RESPONSE TO REQUEST FOR ADDITIONAL INFORMATION

APR1400 Design Certification
Korea Electric Power Corporation / Korea Hydro & Nuclear Power
Docket No. 52-046

RAI No.: 481-8546

Question No. 16-148

3.4.10 Pressurizer Pilot Operated Safety Relief Valves (POSRVs)

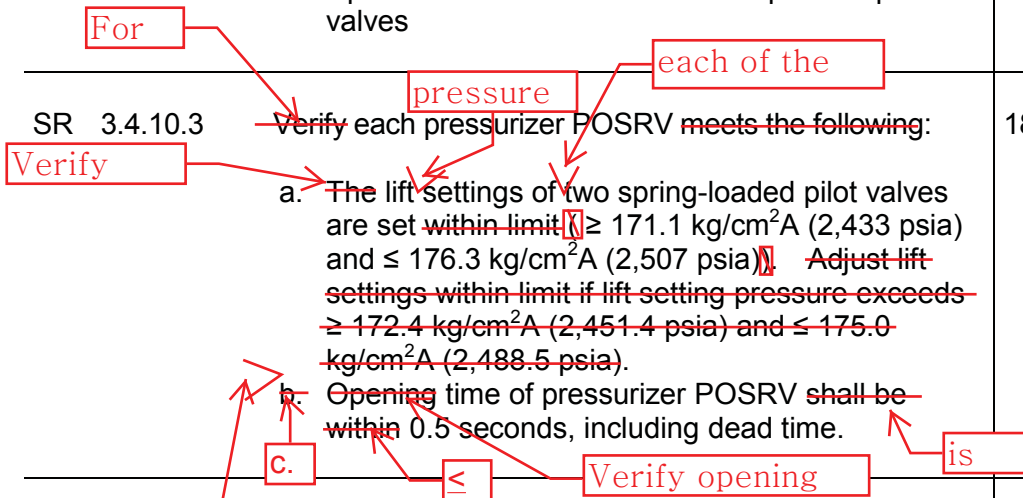
Does “within 0.5 seconds” mean “< 0.5 seconds” or “≤ 0.5 seconds”? Use the appropriate symbol instead of “within” to clarify the POSRV opening time acceptance criterion.

Q5) Does “within 0.5 seconds” mean “< 0.5 seconds” or “ ≤ 0.5 seconds”? Use the appropriate symbol instead of “within” to clarify the POSRV opening time acceptance criterion.

A5) Within (in this context) means ≤ 0.5 seconds. See the mark-ups shown in Attachment 1.

- a. Two spring-loaded pilot valves shall be OPERABLE with lift settings $\geq 171.1 \text{ kg/cm}^2\text{A}$ (2,433 psia) and $\leq 176.3 \text{ kg/cm}^2\text{A}$ (2,507 psia).
- b. The opening time of pressurizer POSRV shall be ~~OPERABLE within 0.5 seconds~~, including dead time
